MODIFICATION RECOMMENDED

N9914A-01

S E R V I C E N O T E

N9914A - FieldFox Handheld Analyzer

Figure 1: No sidebands issue

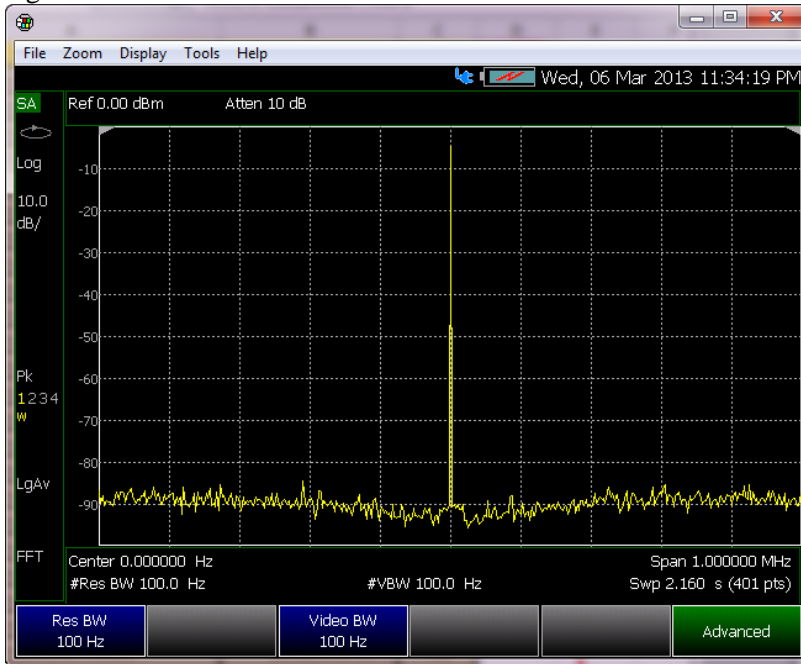
RF board earlier than Rev 7 may have sidebands issue due to oscillation by the voltage regulator. After it is fixed by replacing a new inductor, the RF board revision header will be updated to reflect the change.

Figure 1 shows a good RF signal, and Figure 2 shows FieldFox with sidebands issue.

Affected FieldFox are required to send back to Agilent factory for RF board reliability enhancement. The RF board revision header will be updated to reflect the change. Test and Adjustment shall be done before shipping back to customer.
